Reference: H09/0246/94

Description: Refurbishment of building society branch office

Location : 3 West End Holbeach
Spalding Lincs

TOWN AND COUNTRY PLANNING ACT 1990
REQUIREMENT FOR ADDITIONAL INFORMATION ETC

drawing no.	32-1101-07
revision	00

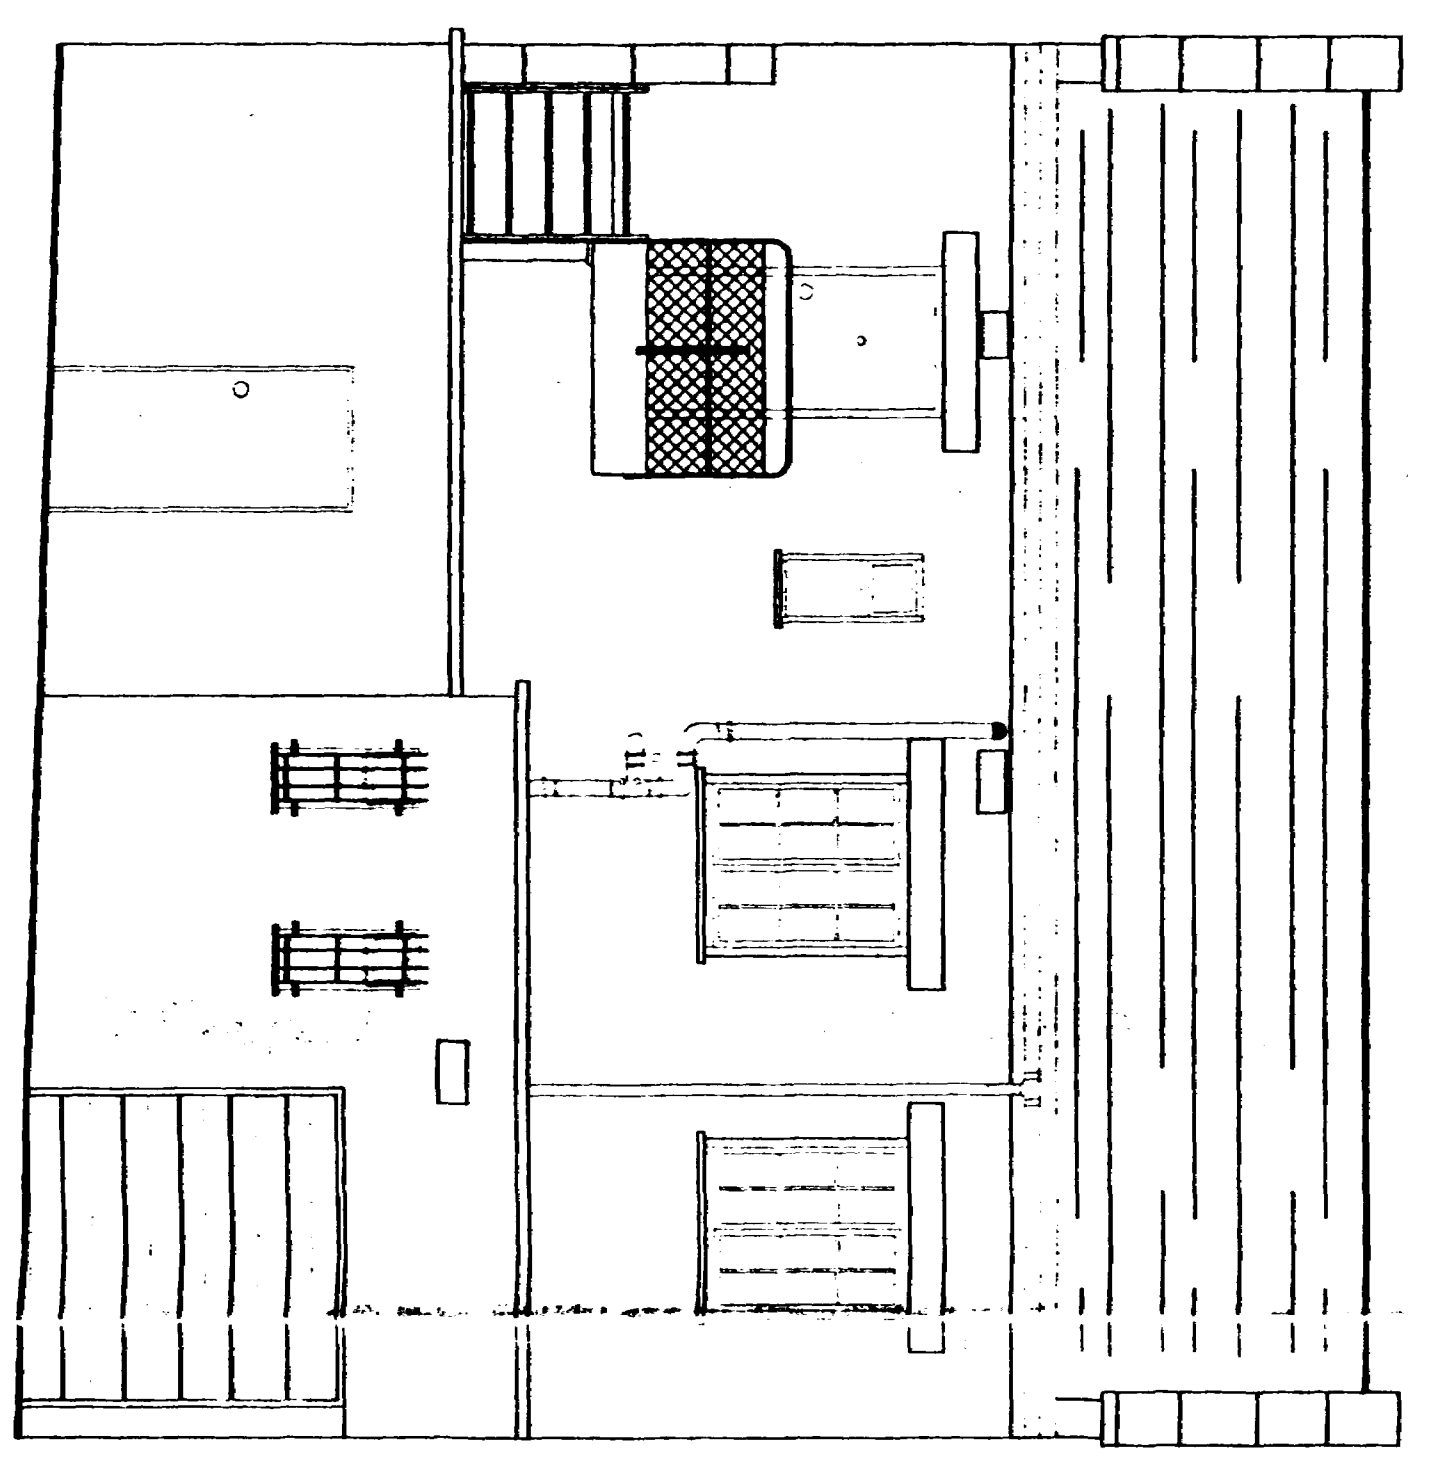
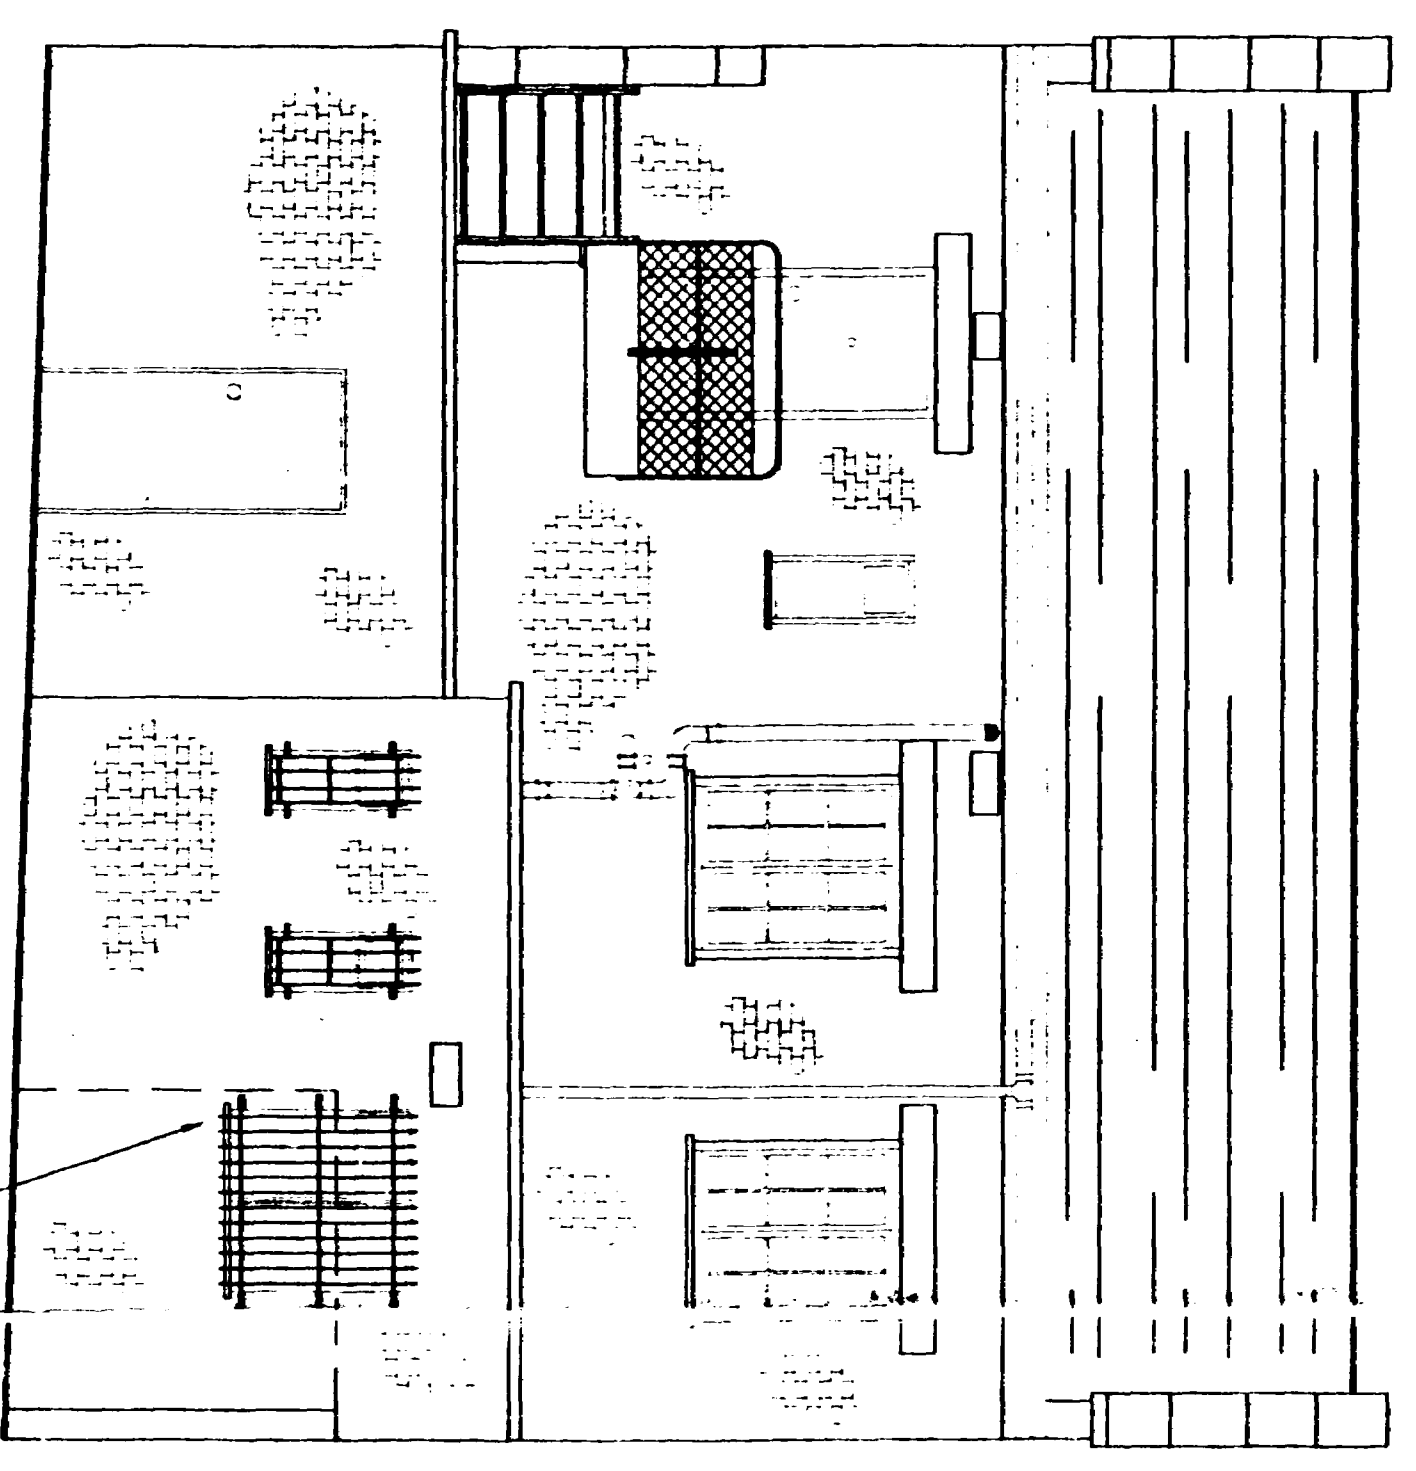
Please show correct notations for rear elevation on plan 32-1101-07.
